PROJECT	21170 Bird in Hand Pub London Borough of Camden	CLIENT	Peacock and Smith			
TITLE	Response to LLFA Comments	REFERENCE	21170-FRA-TN-02	P01		
AUTHOR		CHECKER		APPROVER		
Claire Burroughs MSc DIC MEng, (Hons) MCIWEM		David Mardon MSc Eng, BSc Eng, (Civil) CEng, MICE		Guy Laister MSc Eng, BSc Eng, (Civil) CEng, CEnv, C.WEM		
REV	COMMENTS	DATE	AUTH	CHKR	APPR	
P01	First issue for comment	17/02/2023	CB	DM	GL

2 LLFA Comments and Responses

Figure 1 - Flow Exceedance Direction

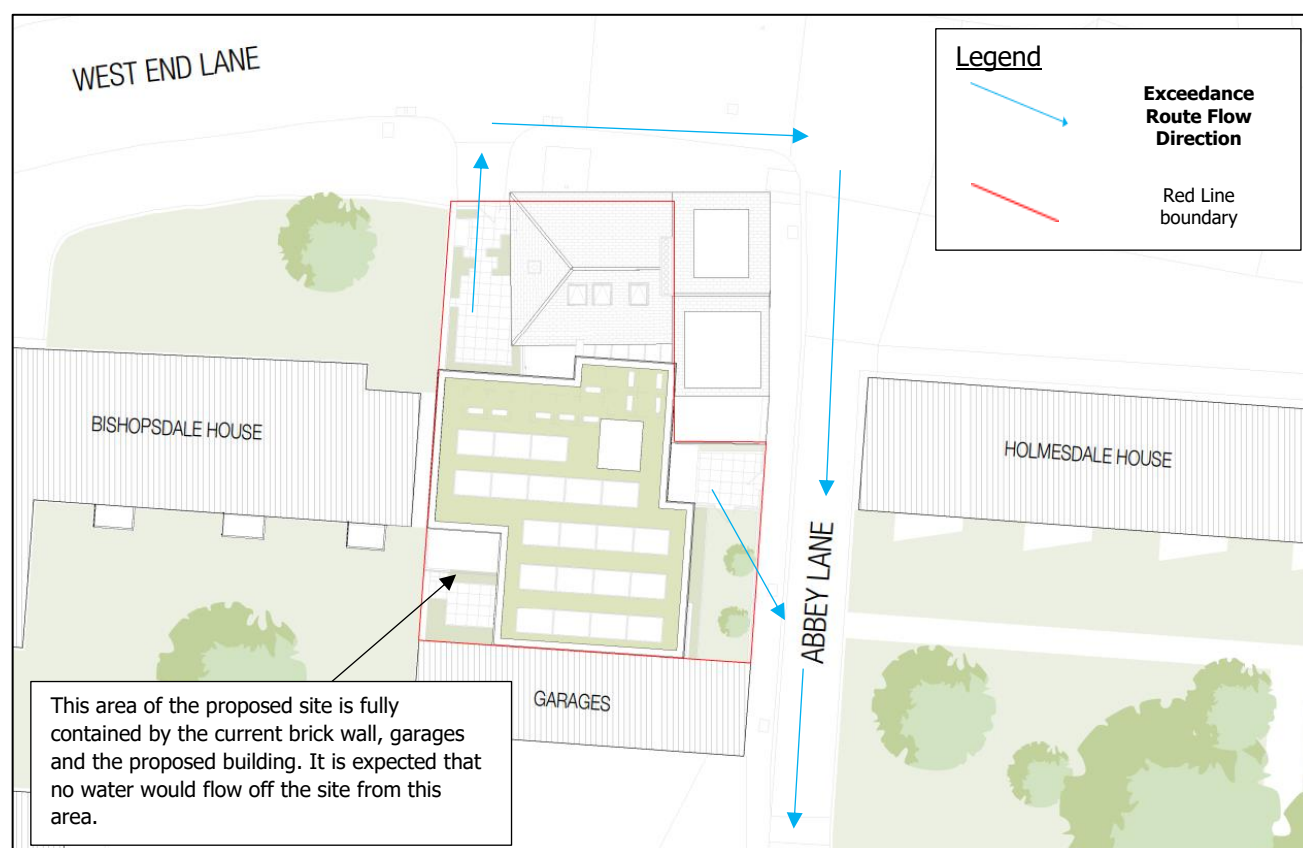
Identify exceedance flows for the 1 in 100 + 40% on the drainage drawing.

- 2.28 For exceedance routes from the proposed SuDS drainage network, as stated previously would follow the local ground levels and the surface water flow routes shown of the GOV.UK Long Term Flooding Maps. This would be along the western side of the development and then southwards.
- 2.29 For clarity, a pictorial image of the predicted exceedance route / surface water flow route off the site and joining the current surface water flow route (GOV.UK Long Term Flooding Maps) is shown in the Figure 1.
